Stevens Creek Trail Overcrossing and Permanente Creek Trail Overcrossing/ Undercrossing—Approve Aesthetic

Design Concepts

STEVENS CREEK TRAIL—SLEEPER AVENUE TO DALE AVENUE/HEATHERSTONE WAY INPUT, QUESTIONS AND ANSWERS FROM AUGUST 27, 2009 COMMUNITY MEETING

PERMANENTE CREEK TRAIL PROJECT—INPUT, QUESTIONS AND ANSWERS FROM

Attachment 1- 5 Stevens Creek Trail Renderings

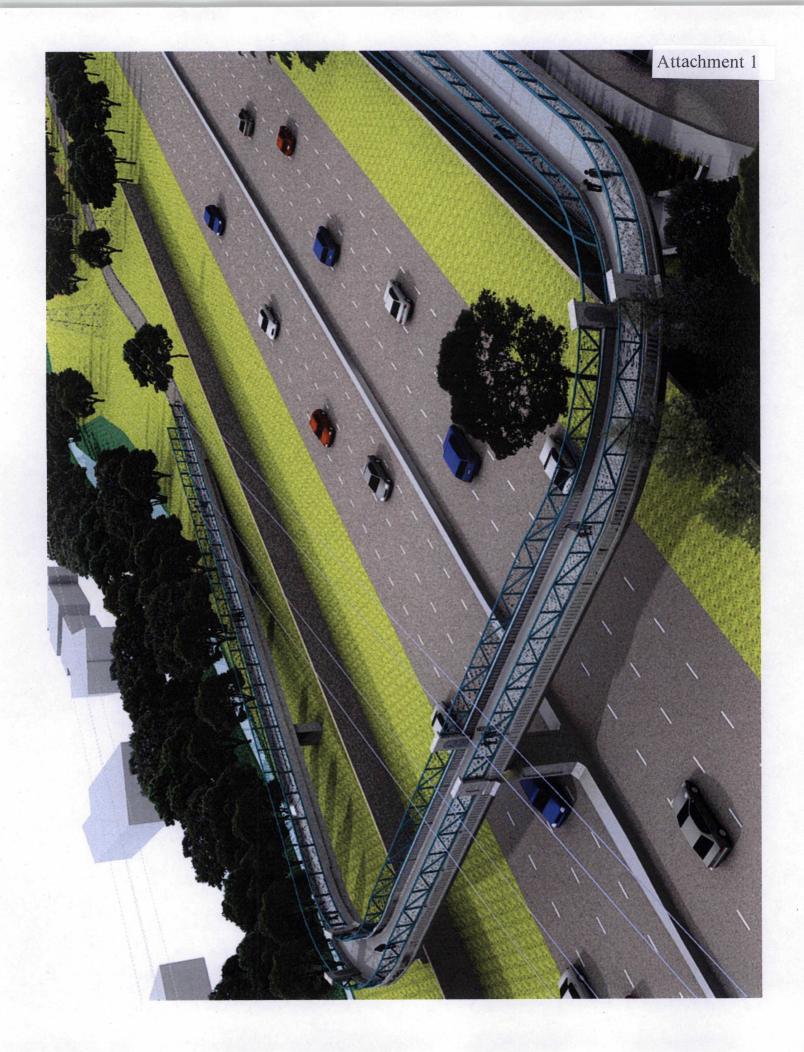
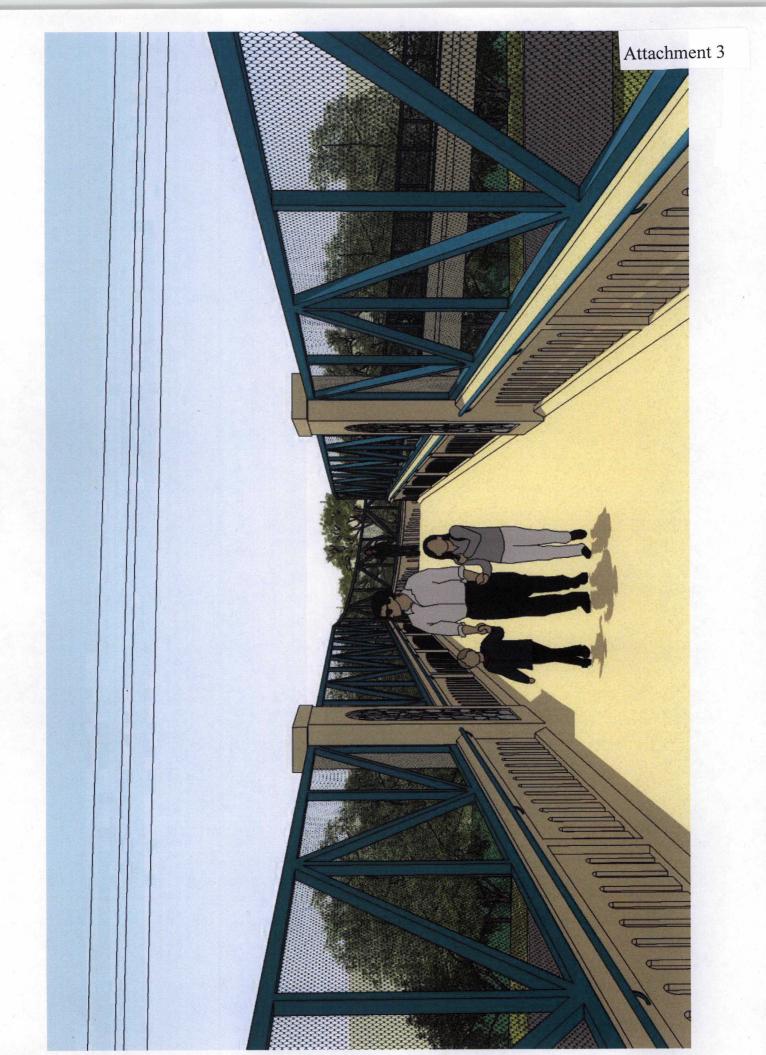
Question: Will the surface of the pedestrian overcrossing be concrete or wood?

- Input: My son will use the overcrossing to get to school and my family is looking forward to its completion.
- Question: Did the City consider covering the top of the overcrossing to prevent trash from being thrown off the side?

Answer: Concrete.

Answer: Caltrans does not require a cover and all of the most recently constructed pedestrian overcrossings along Highways 101, 237 and 85 do not have a cover.

Permanente Creek Trail Over/Undercrossing Renderings

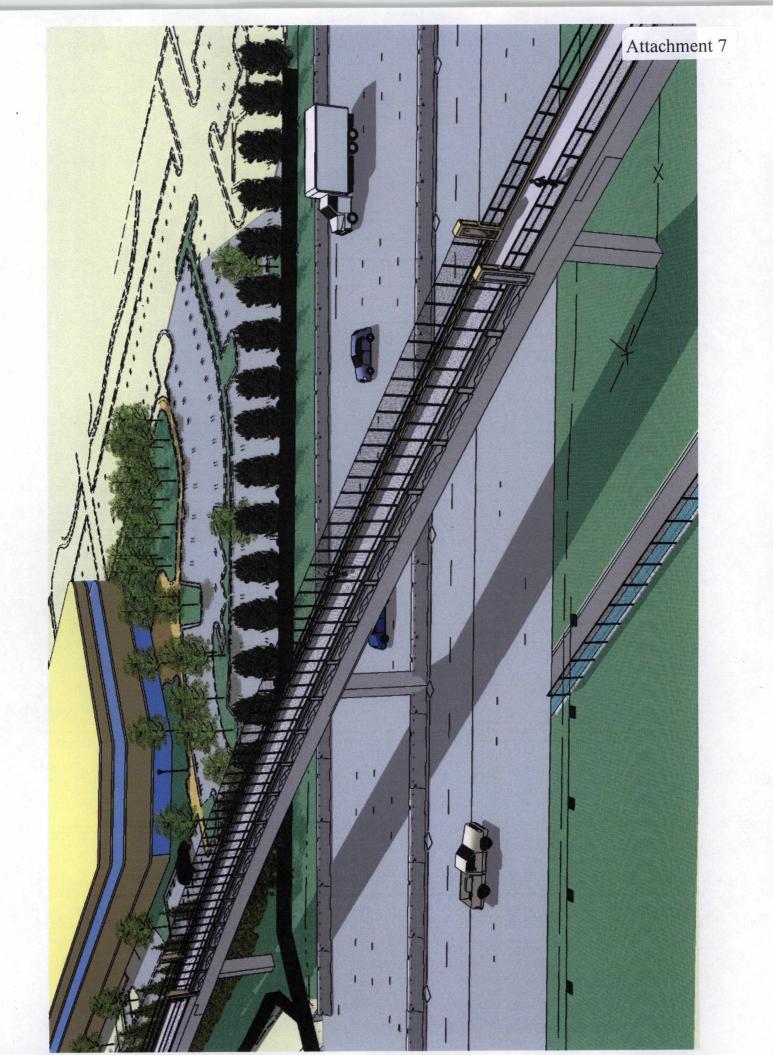
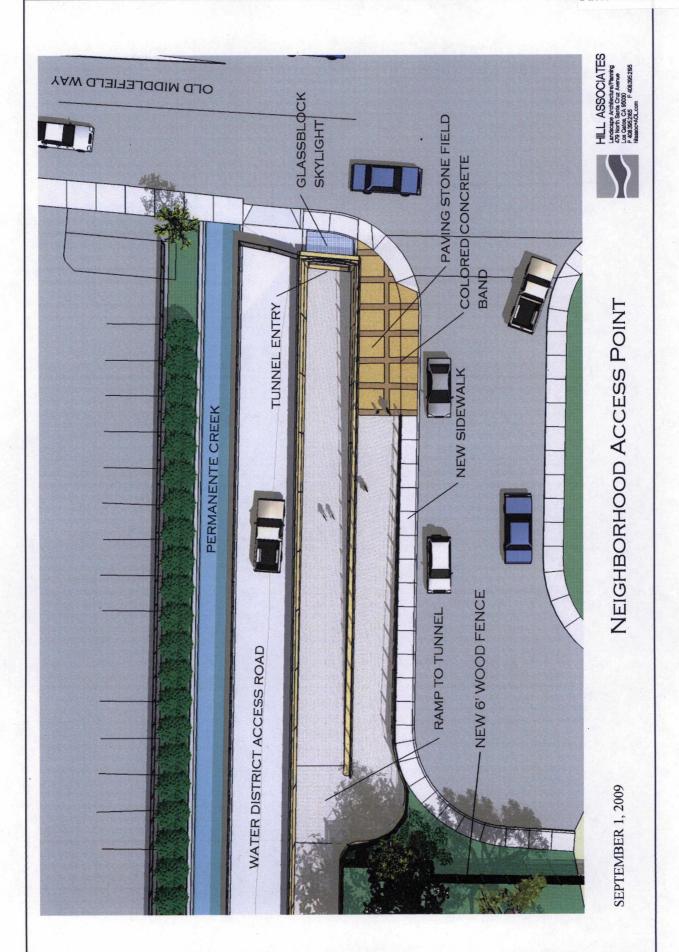
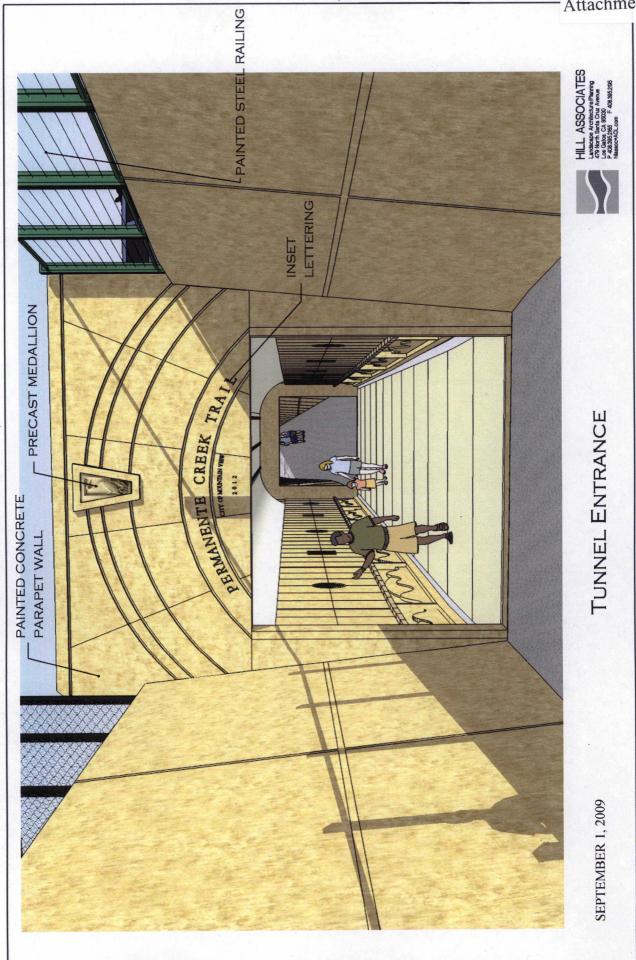
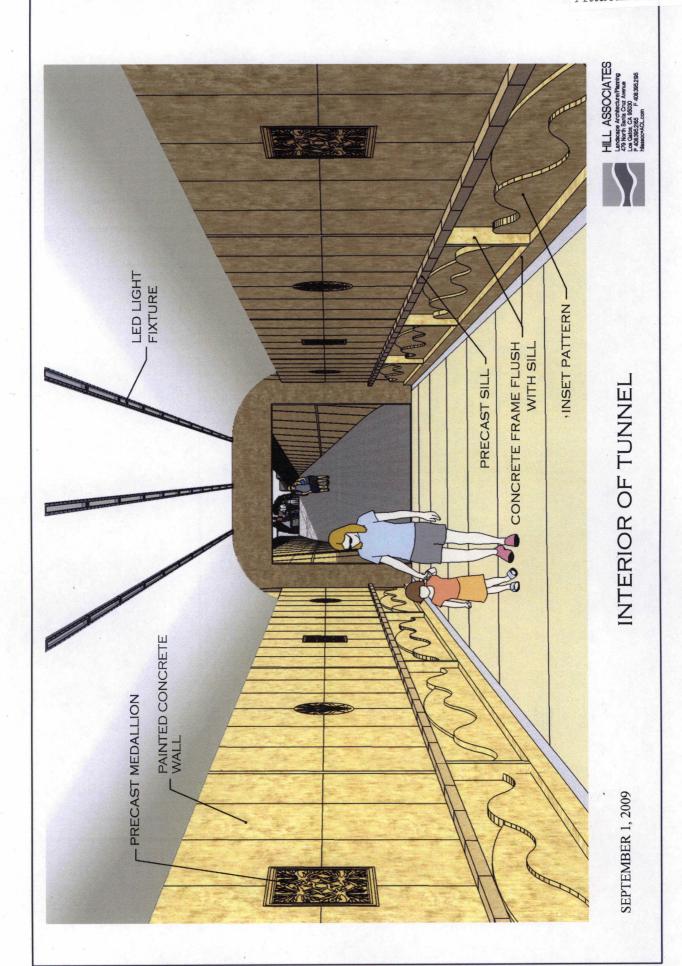
• Question: How will the project withstand vandalism? How frequently will the City clean graffiti from the tunnel?

Question: Who will decide on the medallion design?

• Question: Will there be a bike maze on both sides of the overcrossing? Do the bike mazes allow for trailers?

• Question: How will the drainage be handled from water falling on the impervious structures?

Question: Will the medallions be painted during construction? If not, can the medallions be painted if tagged by graffiti?

Question: Will the overcrossing structure be lit?

Answer: The project materials and features will be durable and paintable. Even the medallions will be paintable. The lights will be industrial-grade and vandal-resistant. The trail will be patrolled by City ranger staff when open.

Answer: The medallions will be designed by the project landscape architect with City approval. The intent is to show animals and plants from the Permanente Creek riparian corridor.

Answer: There will be bike mazes on both sides. The design team will look into the feasibility of accommodating trailers.

Answer: The drainage will be diverted from the surface of the structure to an infiltration swale and to existing storm drains.

Answer: No; however, the medallions can be painted if tagged.

Answer: City trails are open from dusk until dawn so the current City policy is to not light the overcrossing. However, the project will install conduit in the structure so that lighting could be easily installed if that policy were to change in the future.
